Submission on Reference: SSD 5066/EPBC 2011/6086 Provided by Allan Corben 13 Woolmer's Court Wattle Grove NSW 2173 P/N 0451 998 774 Email allancorben@bigpond.com

MICL EIS notes Chapter 12 Noise & Vibration

Page 44 Controlling noise propagation

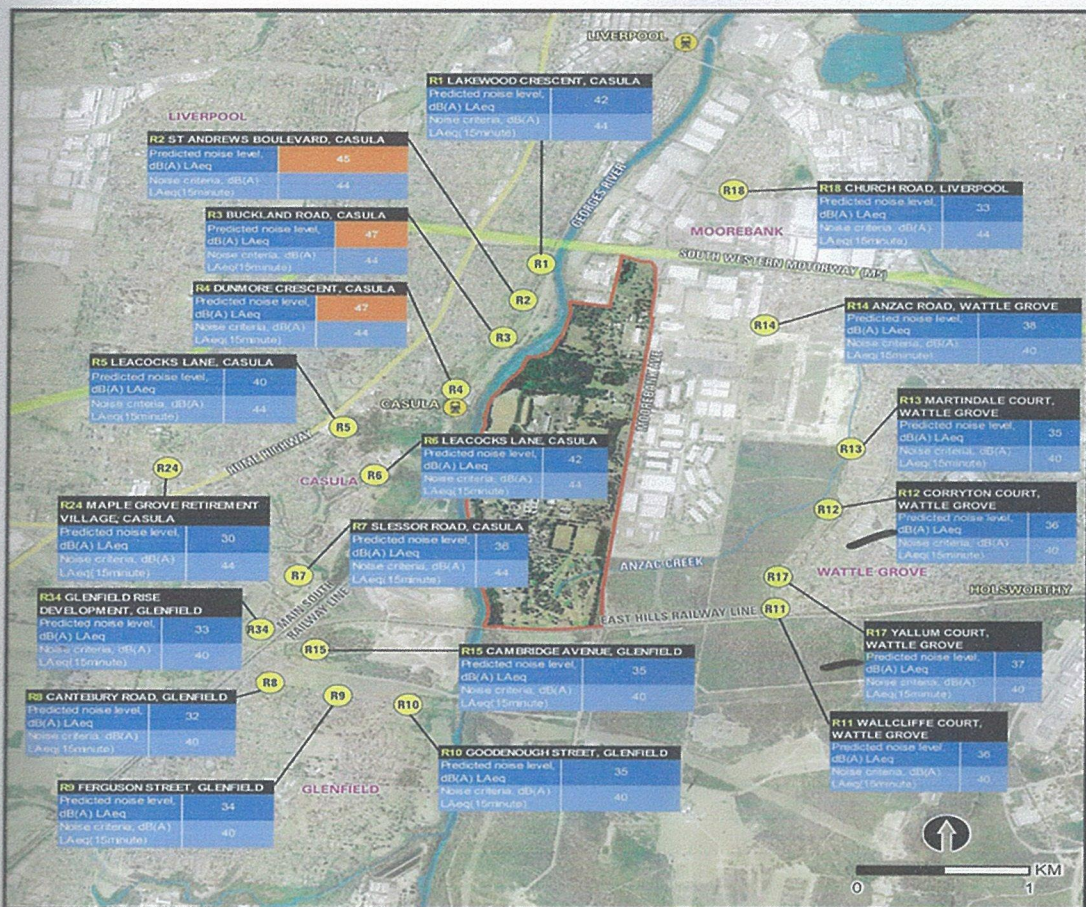
TEU containers could be used as noise barriers where they are stacked, to eliminate gaps or openings and to effectively impede the direct line of sight to nearest receptors. This is likely to require an operational management procedure to ensure the container areas adjacent to the residential communities are maintained so that the containers are at the maximum practicable eight at all times (typically up to five TEU). ***This statement is open ended and is in no way any form of guarantee as M/T TEU's might not be available to ensure that the impacted residents are consistently protected 24/7***
